ADDENDUM No. 1

REQUEST FOR QUOTATIONS (RFQ) NO.: 1220-040-2013-026

TITLE: REPLACE BOILER AT SURREY ARTS CENTRE

1. DRAWING NO. M2.01

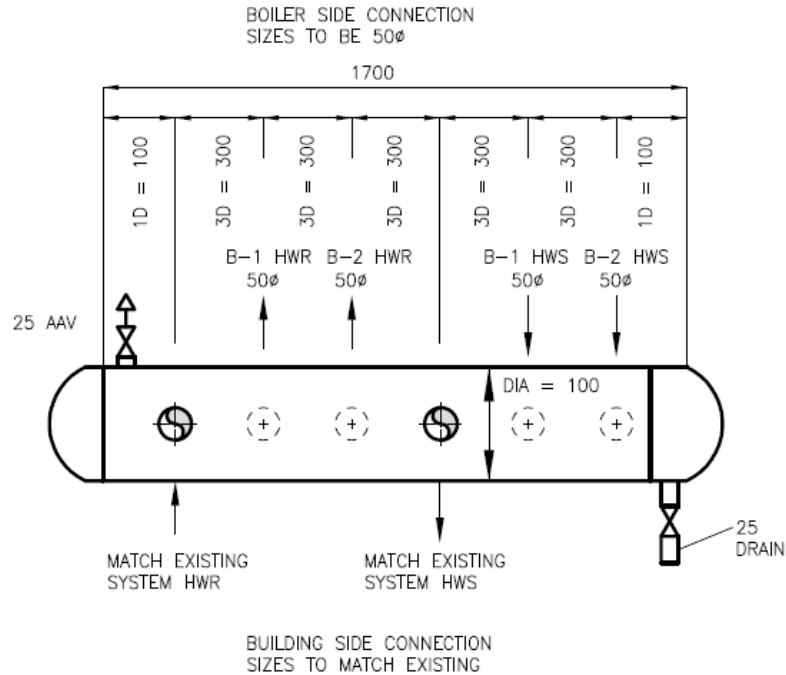
REVISE:

Boiler B-1 & B-2 supply and return piping to connect to low loss header individually.
